ADDENDUM NO. 1

Farmington Correctional Center – Service Add Electrical Circuits to Emergency
Generator Food Services Warehouse

Farmington MO 63640
PROJECT NO. C2238-01

E0.1

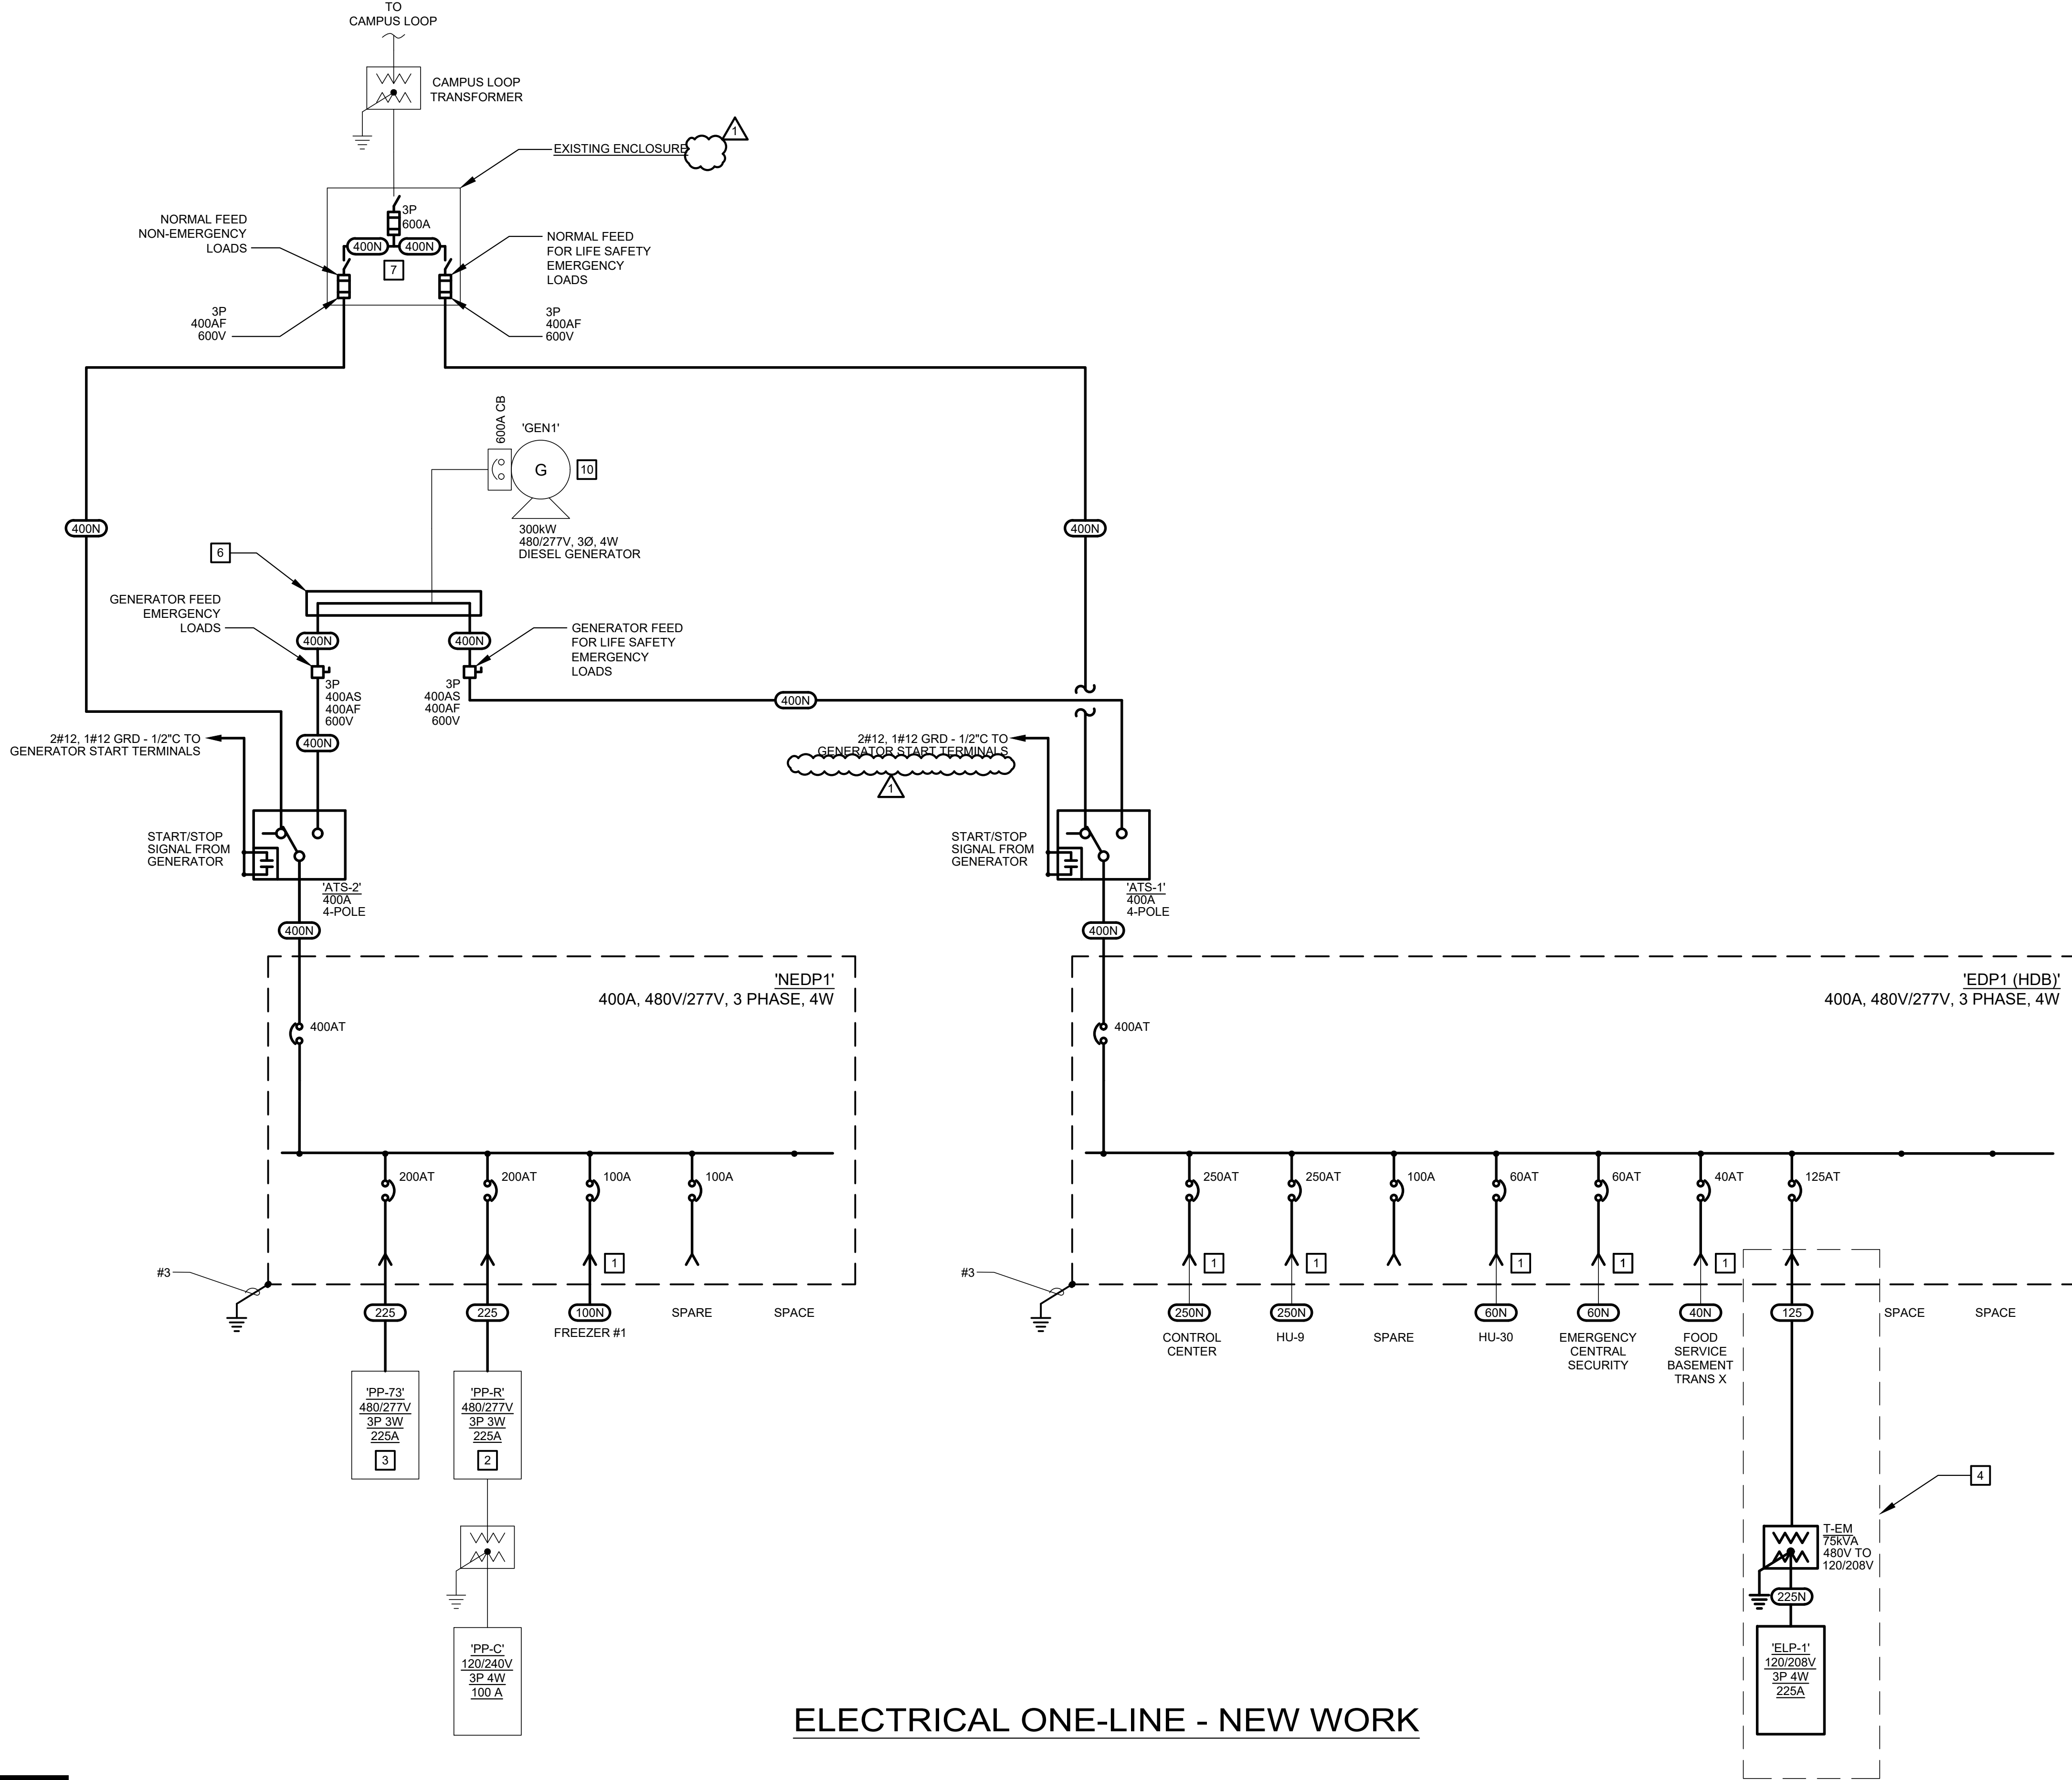
1. Drawing E0.1
 1. *"DELETE" Removed a keyed note symbol that was not applicable to the enclosure it was adjacent.*
 2. *"DELETE" Removed notes to more accurately describe the scope of the project.*
